Access Compliance Report

Public Rights-of-Way

Intersection ID: 15543	Main Street: EXECUTIVE_CENTER_DR	Cross Street: HOLLINS_DR	Location: SW
ADA ID: B3AD427924ED	Ramp Type: PerpDiag	Initial Pass/Fail: Fail	Overall Compliance: No
Severity Score: 33.75			
Codes/Mitigation Info/Possible Solution		Field Measurements/Component Compliance

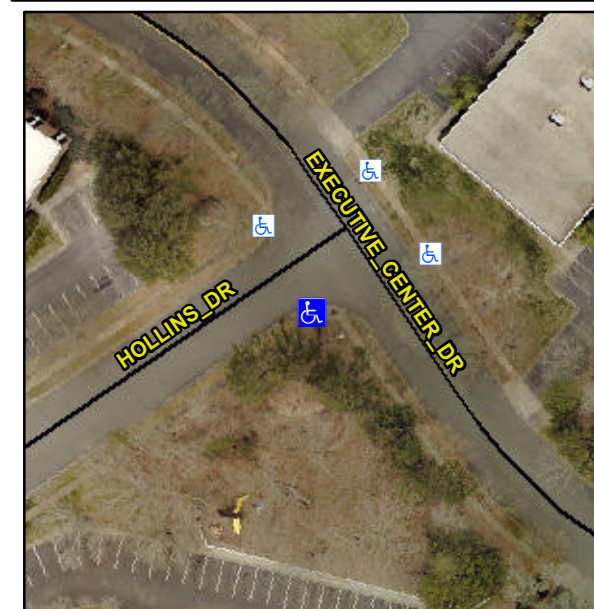
Not Found, R304.5.1, R304.2.2

Compliance	Description	Data	Compliance	Description	Data
N/A	Ramp Length (in)	59.0	No	Ramp Slope (%)	12.3
No	Ramp Width (in)	43.0	Yes	Ramp XSlope (%)	0.0
N/A	Flare Type LT	N/A	N/A	Flare Type RT	N/A
N/A	Flare Slope LT (%)	N/A	N/A	Flare Slope RT (%)	N/A
N/A	Flare Traversable LT?	N/A	N/A	Flare Traversable RT?	N/A
N/A	Landing Length (in)	N/A	N/A	DWS Provided?	N/A
N/A	Landing Width (in)	N/A	N/A	DWS Contrast?	N/A
N/A	Landing Slope (%)	N/A	N/A	DWS Length (in)	N/A
N/A	Landing X Slope (%)	N/A	N/A	DWS Full Width?	N/A
N/A	Landing Curb? (Y/N)	N/A	N/A	DWS Offset (in)	N/A
N/A	Shared Landing?	N/A			
N/A	Gutter Ponding?	N/A	N/A	Gutter Slope (%)	N/A
N/A	Gutter Lip Ht (in)	N/A	N/A	Gutter X Slope (%)	N/A
N/A	Painted X Walk1?	No	N/A	Painted X Walk2?	No
	X Walk 1 Direction	To NE		X Walk 2 Direction	To NW
N/A	X Walk 1 Width (in)	N/A	N/A	X Walk 2 Width (in)	N/A
	X Walk 1 Slope (%)	4.6		X Walk 2 Slope (%)	3.7
	X Walk 1 X Slope (%)	2.7		X Walk 2 X Slope (%)	2.1

Remove & Replace Curb Ramp With Two New Directional Ramps or Equivalent.
